Subject: Supplementary Information on Proposed Changes for the AP1000 Design Control Document Rev. 18

This letter provides supplementary information on the design change (Change Number 62) which addresses a redesign of the reactor vessel support system. Information on CN62 was initially provided in Reference 5. The supplementary information, which consists of responses to comments provided by the NRC is provided in Enclosure 1. The resolution of these comments did not affect the DCD.

Supplementary Information for CN62
Redesign of Reactor Vessel Support System
Non-Proprietary

Figure 1: RPV support FEA model and the stress intensity results for the controlling Level D horizontal load case.

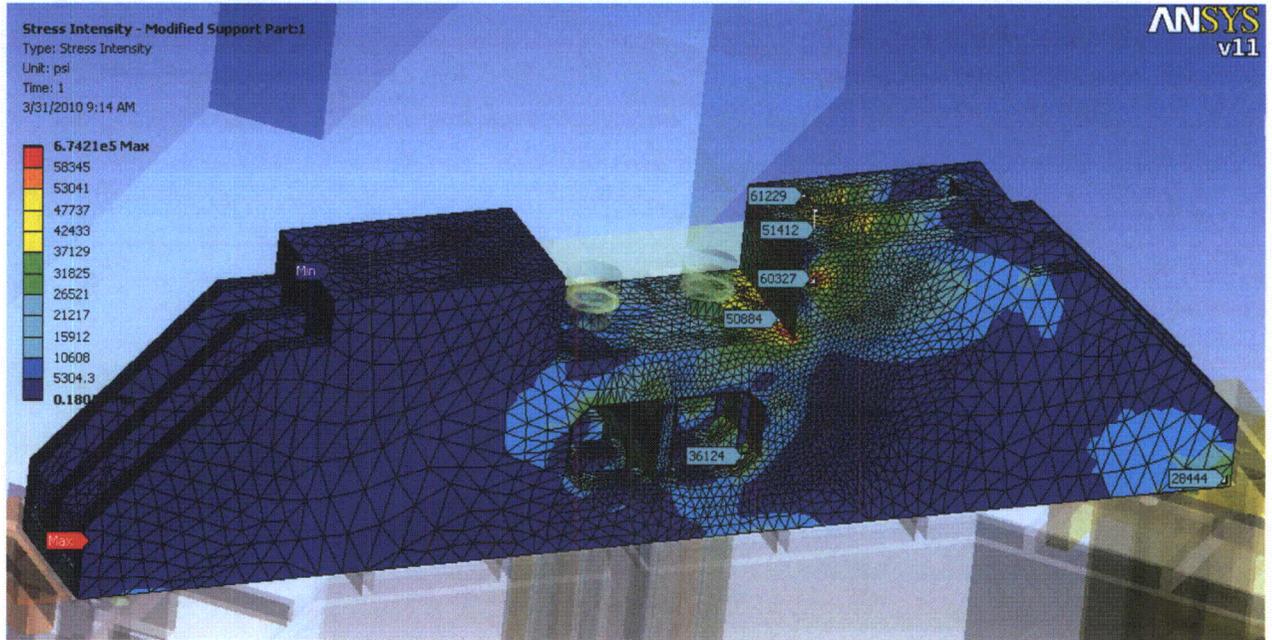
1. NRC Comment: *Provide a stress analysis on the new design of the RV support box structure, showing the critical section bearing the maximum stress. Provide the comparison with the maximum stress in the old design and show that the new design is in compliance with the adopted code requirements.*

The final AP1000 reactor pressure vessel (RPV) support was designed to the requirements of design specification APP-SS30-Z0-001, Revision 1. Accordingly, the RPV support design meets the requirements of the ASME B&PV Code, Section III, Subsection NF, 1998 Edition with Addenda up to and including 2000. The support is classified as NF Class 1.

The RPV structural analysis and qualification is summarized in calculation APP-PH01-Z0C-007, Revision 0, May 26, 2010. The design was confirmed by utilizing a 3-dimensional finite element analysis (FEA) model to perform the analysis. The general purpose FEA computer code ANSYS was used for the modeling, analysis and results post processing. Linearized primary membrane (Pm) and primary membrane plus bending (Pm+Pb) stress intensities were computed and compared to the allowable stress limits of ASME NF-3220 for the Level A, B, C, and D load combinations. The Level D loading condition controls the design.

Figure 1, Figure 5-39(a) from calculation APP-PH01-Z0C-007, shows the RPV support FEA model and the stress intensity results for the controlling Level D horizontal load case. Thirty-two individual paths were chosen in the high stress regions shown above to compute the linearized stresses. The controlling stress interaction ratios for the Level D loading condition are Pm = 96.86% of allowable and Pm+Pb = 90.86% of allowable. Note all plate material is specified as ASTM A572, Grade 50 per Code Case N-71-18.
